UNITED STATES PATENT AND TRADEMARK OFFICE

APPLICATION NO.	FILING DATE	FIRST NAMED INVENTOR	ATTORNEY DOCKET NO.	CONFIRMATION NO.
10/782,966	02/23/2004	Shinya Marushima	NIP-149-05	7565

Office Action Summary

DETAILED ACTION***Drawings***

Fig. 4C**Figures 4A, 4C of Carreno.**

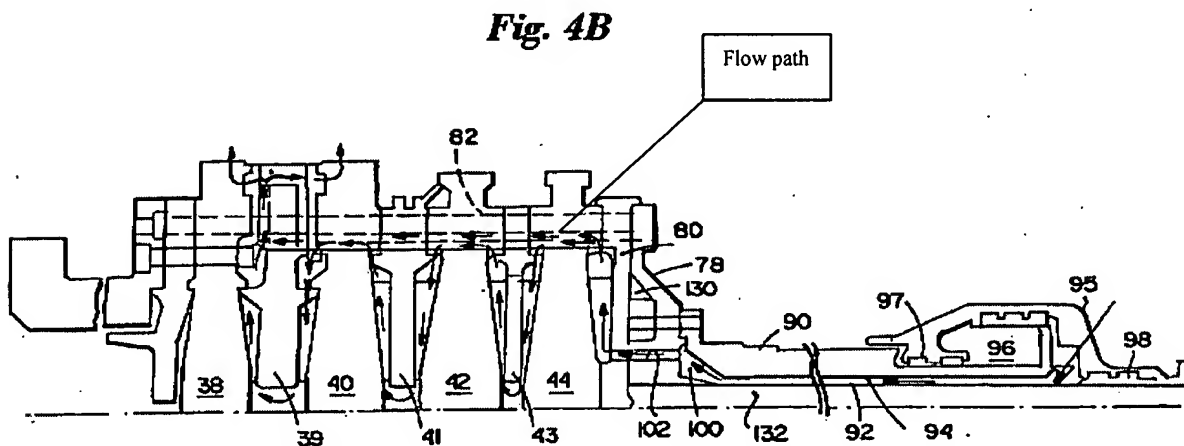
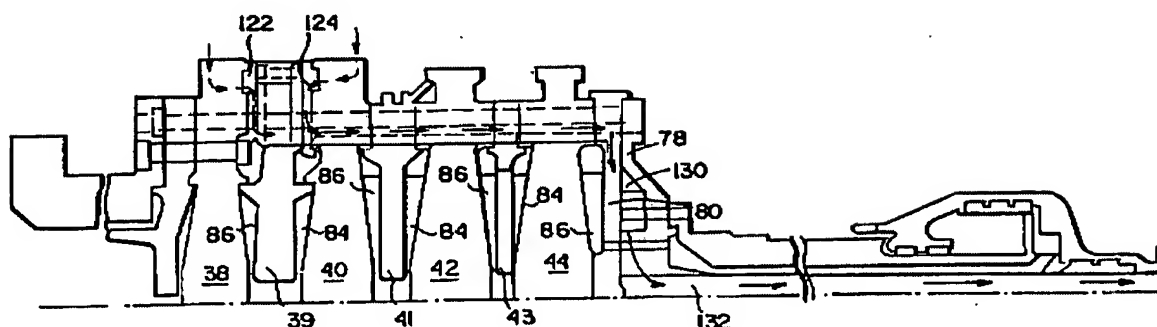
With respect to claim 11, **Carreno** teaches a gas turbine which a rotor shaft comprises a plurality of discs 38, 40, 42, 44 each having a plurality of moving blades arranged annularly on the peripheral portion, and spacers 39, 41, 43 arranged between said discs, said respective discs 38, 40, 42, 44 and spacers being arranged in an axial direction in turn, comprising: gap portions 84, 86 formed between rotor axis side regions of said discs 38, 40, 42, 44 facing said spacers 39, 41, 43 and adjacent spacers; a supply flow path 92 for supplying refrigerant for cooling to said moving blades and a recovery flow path 132 for recovering heated refrigerant, each of said supply and recovery flow paths being provided in said rotor shaft; a flow path (see Figure 4B) for introducing fluid into said gap portions 84, 86 provided in said discs (see particularly **Figures 4B, 4C** of **Carreno** above). **Carreno** does not schematically show that the recovery flow path is arranged on a more radially outer side than said supply flow path but said recovery flow path 132 is arranged on a more radially inner side than said supply flow path 92. However, **Suenaga** teaches a typical heat recovery type gas turbine similar to **Carreno's** heat recovery type gas

turbine, wherein the recovery flow path 11 is arranged on a more radially outer side than said supply flow path 11. Accordingly, it would have been prima facie obvious to one of ordinary skill in the art at the time the invention was made to have modified Carreno (as taught by Suenaga) such that the recovery flow path is arranged on a more radially outer side than said supply flow path because such a modification would have not affected the efficient operation of Carreno's gas turbine and further such modification would have been considered a mere design consideration which fails to patentably distinguish over Carreno. See particularly **Figure 1** of Suenaga.

With respect to claim 12, **Carreno** teaches a gas turbine which a rotor shaft comprises a plurality of discs 38, 40, 42, 44 each having a plurality of moving blades arranged annularly on the peripheral portion, and spacers 39, 41, 43 arranged between said discs, said respective discs 38, 40, 42, 44 and spacers being arranged in an axial direction in turn, comprising: gap portions 84, 86 formed between rotor axis side regions of said discs 38, 40, 42, 44 facing said spacers 39, 41, 43 and adjacent spacers; a supply flow path 92 for supplying steam for cooling to said moving blades and a recovery flow path 132 for recovering heated steam, each of said supply and recovery flow paths being provided in said rotor shaft; a flow path (see Figure 4B) for introducing fluid into said gap portions 84, 86 provided in said discs (see particularly **Figures 4B, 4C**, and column 1 lines 65-67 of Carreno). **Carreno** does not schematically show that the recovery flow path is arranged on a more radially outer side than said supply flow path but said recovery flow path 132 is arranged on a more radially inner side than said supply flow path 92. However, **Suenaga** teaches a typical heat recovery type gas turbine similar to Carreno's heat recovery type gas turbine, wherein the recovery flow path 11 is arranged on a more radially outer

FIG. 25
PRIOR ART

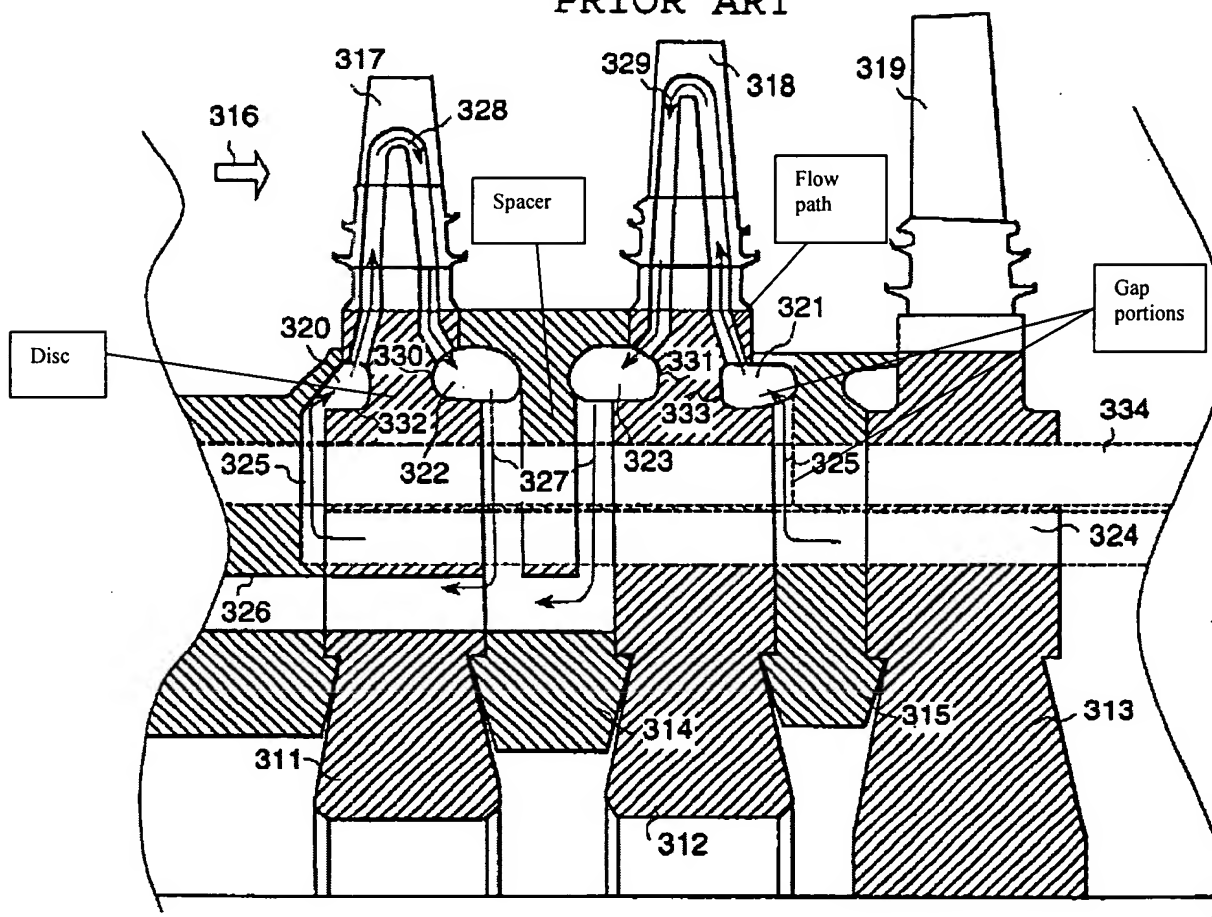
With respect to claim 11, **Akiyama** teaches a gas turbine which a rotor shaft comprises a plurality of discs each having a plurality of moving blades arranged annularly on the peripheral portion, and spacers arranged between said discs, said respective discs and spacers being arranged in an axial direction in turn, comprising: gap portions formed between rotor axis side

regions of said discs facing said spacers and adjacent spacers; a supply flow path 324 for supplying refrigerant for cooling to said moving blades and a recovery flow path 326 for recovering heated refrigerant, each of said supply and recovery flow paths being provided in said rotor shaft; a flow path for introducing fluid into said gap portions provided in said discs (see particularly **Figure 25** of **Akiyama** above). **Akiyama** does not schematically show that the recovery flow path is arranged on a more radially outer side than said supply flow path but said recovery flow path 326 is arranged on a more radially inner side than said supply flow path 324. However, **Suenaga** teaches a typical heat recovery type gas turbine similar to **Akiyama's** heat recovery type gas turbine, wherein the recovery flow path 11 is arranged on a more radially outer side than said supply flow path 11. Accordingly, it would have been prima facie obvious to one of ordinary skill in the art at the time the invention was made to have modified **Akiyama** (as taught by **Suenaga**) such that the recovery flow path is arranged on a more radially outer side than said supply flow path because such a modification would have not affected the efficient operation of **Akiyama's** gas turbine and further such modification would have been considered a mere design consideration which fails to patentably distinguish over **Akiyama**. See particularly **Figure 1** of **Suenaga**.

With respect to claim 12, **Akiyama** teaches a gas turbine which a rotor shaft comprises a plurality of discs each having a plurality of moving blades arranged annularly on the peripheral portion, and spacers arranged between said discs, said respective discs and spacers being arranged in an axial direction in turn, comprising: gap portions formed between rotor axis side regions of said discs facing said spacers and adjacent spacers; a supply flow path 324 for

supplying steam for cooling to said moving blades and a recovery flow path 326 for recovering heated steam, each of said supply and recovery flow paths being provided in said rotor shaft; a flow path for introducing fluid into said gap portions provided in said discs (see particularly **Figure 25**; and column 5 lines 40-46 of **Akiyama**). **Akiyama** does not schematically show that the recovery flow path is arranged on a more radially outer side than said supply flow path but said recovery flow path 326 is arranged on a more radially inner side than said supply flow path 324. However, **Suenaga** teaches a typical heat recovery type gas turbine similar to **Akiyama**'s heat recovery type gas turbine, wherein the recovery flow path 11 is arranged on a more radially outer side than said supply flow path 11. Accordingly, it would have been prima facie obvious to one of ordinary skill in the art at the time the invention was made to have modified **Akiyama** (as taught by **Suenaga**) such that the recovery flow path is arranged on a more radially outer side than said supply flow path because such a modification would have not affected the efficient operation of **Akiyama**'s gas turbine and further such modification would have been considered a mere design consideration which fails to patentably distinguish over **Akiyama**. See particularly **Figure 1** of **Suenaga**.
